**MUMBAI METRO RAIL CORPORATION LIMITED**

**Mumbai Metro Line-3 Project**

**Design, Manufacture, Supply, Installation, Testing & Commissioning of A) Synchronized Under Floor Lifting Syatem B) Synchronized Mobile Lifting Jacks, and C) Bogie Turn Tables**

**Response to Bidders' Queries (SET-1)**

Drawing Title : Aarey Depot Masterplan

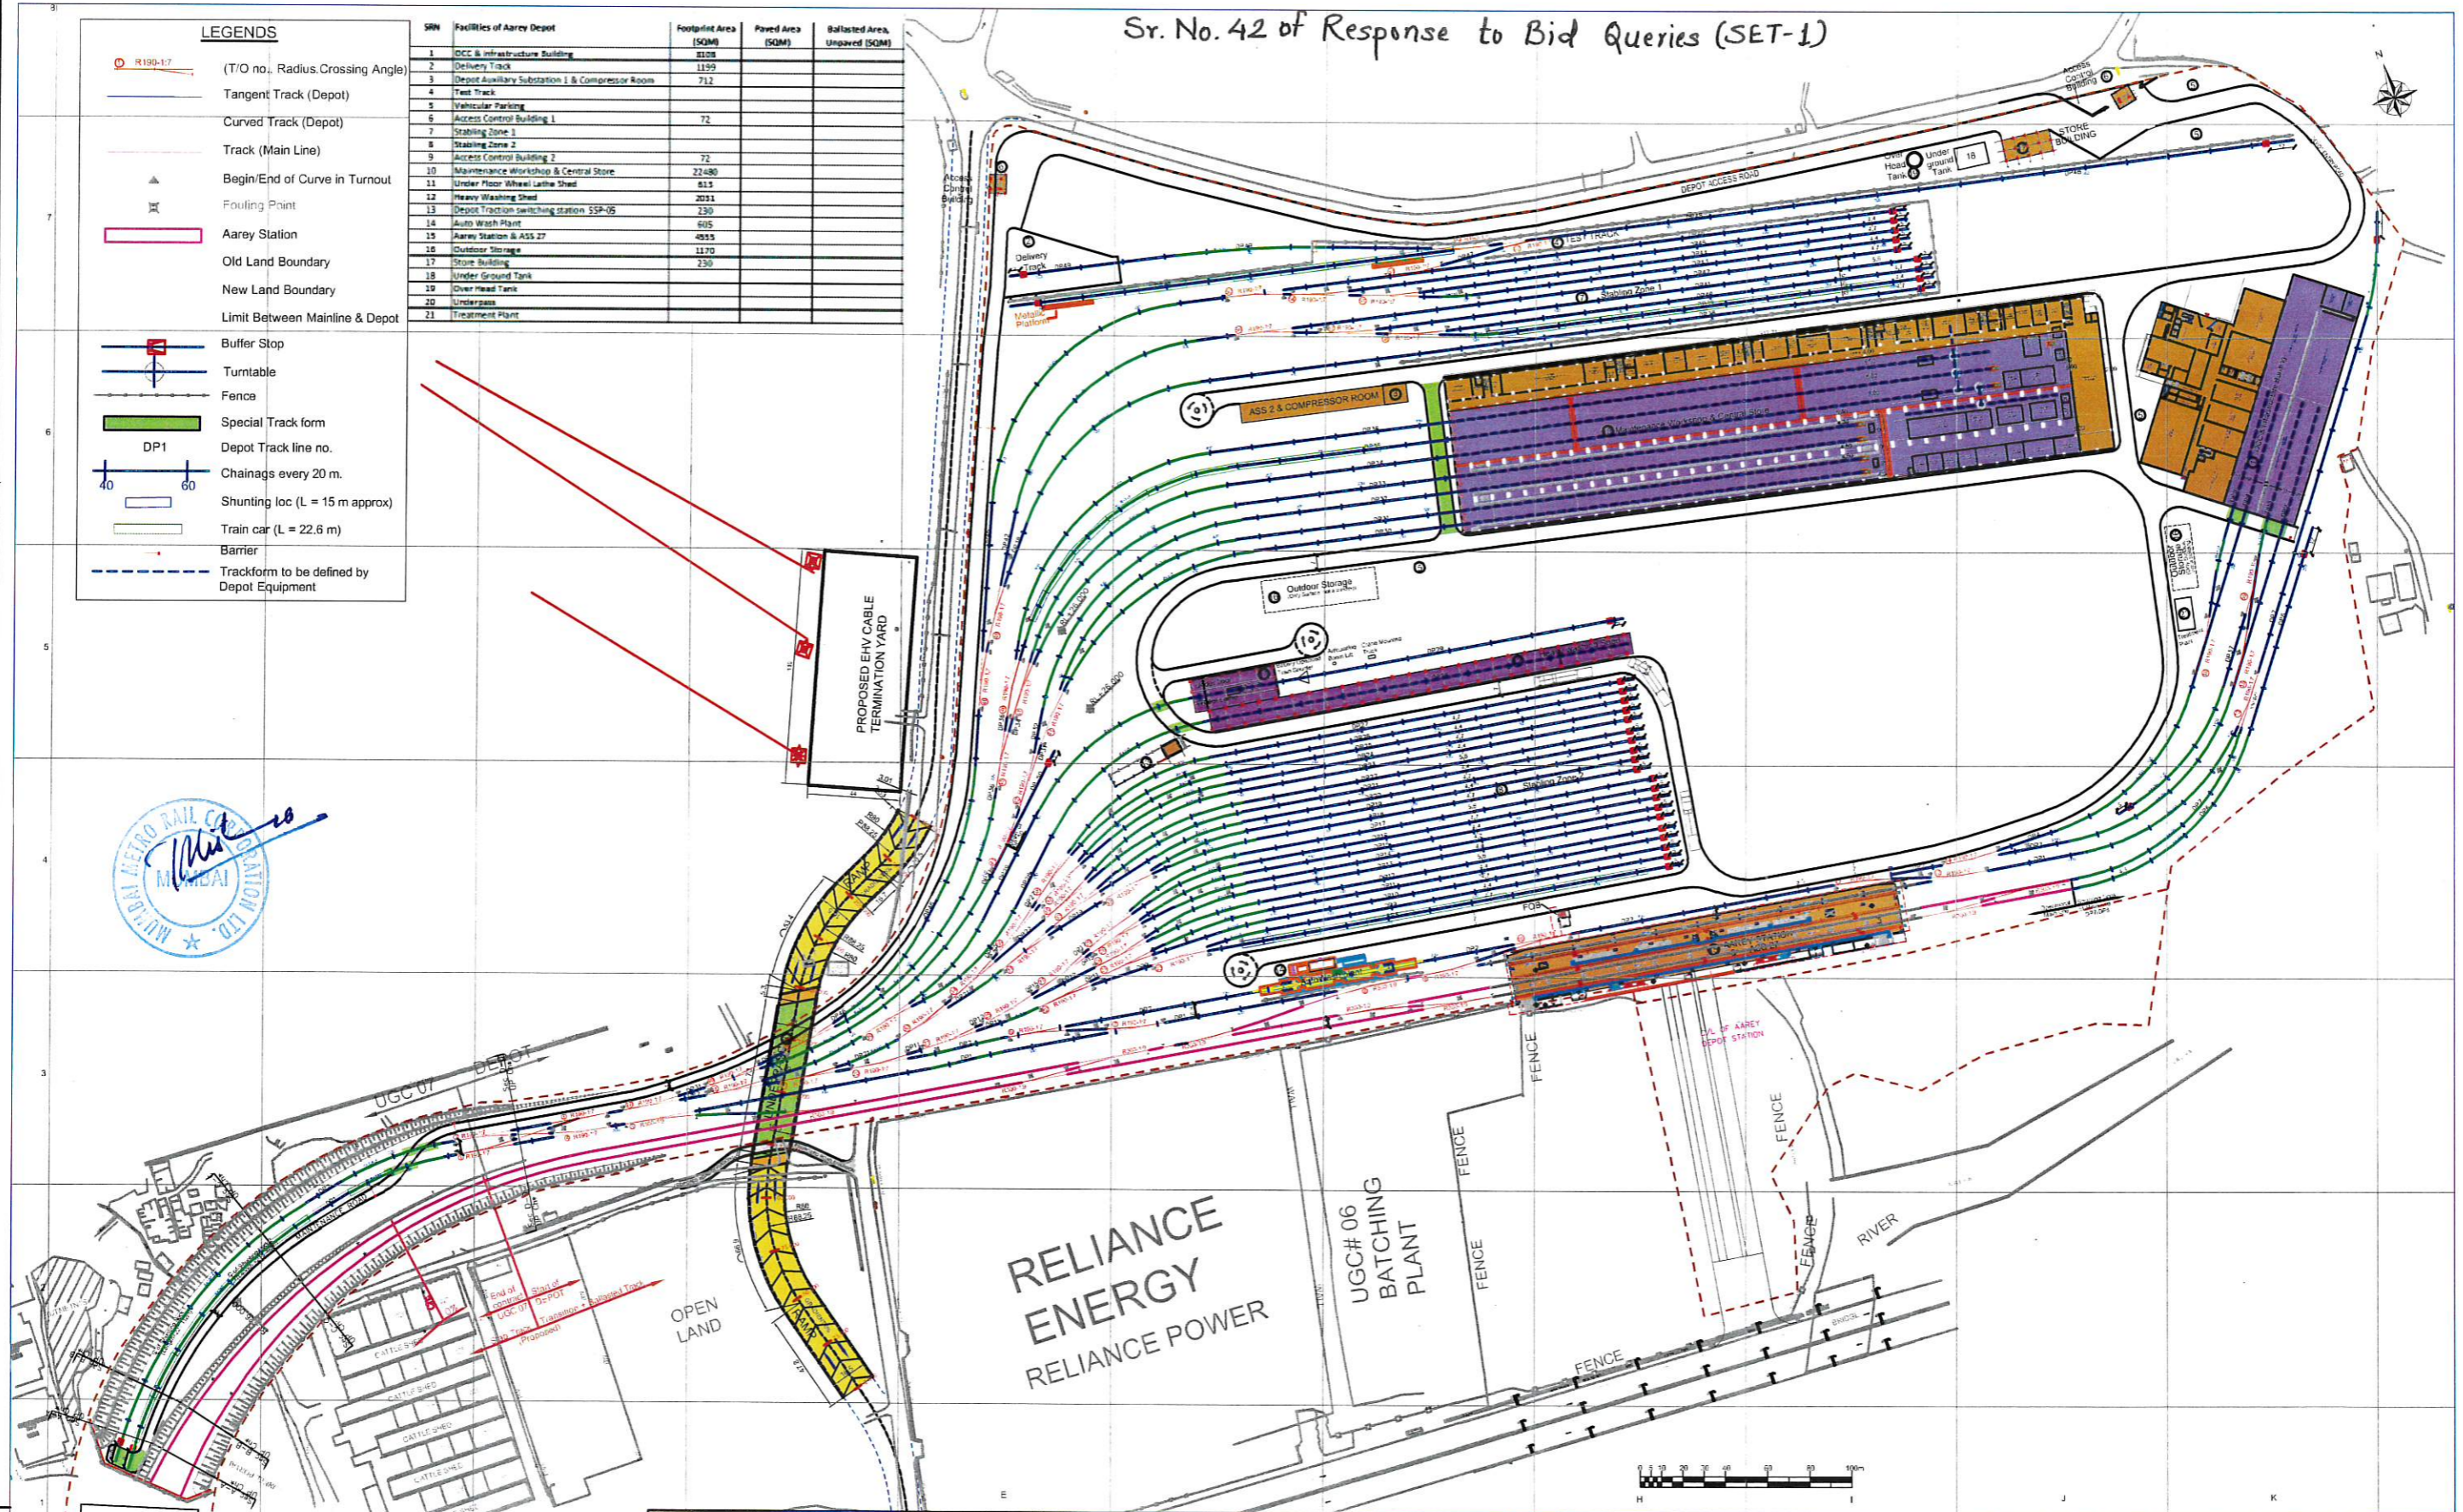
42	Part 4			List of Drawings	The drawings provided in the tender document are not readable. Hence, we request you to kindly provide us drawings with high resolution.  Also, please provide Kinematic Envelope of train.	The drawings provided in the RFP are only indicative and attached again with response sheet. Final drawings are to be obtained from Project Managers/Interfacing Contractors after the Award of Contract.  <b>Bid conditions prevail.</b>
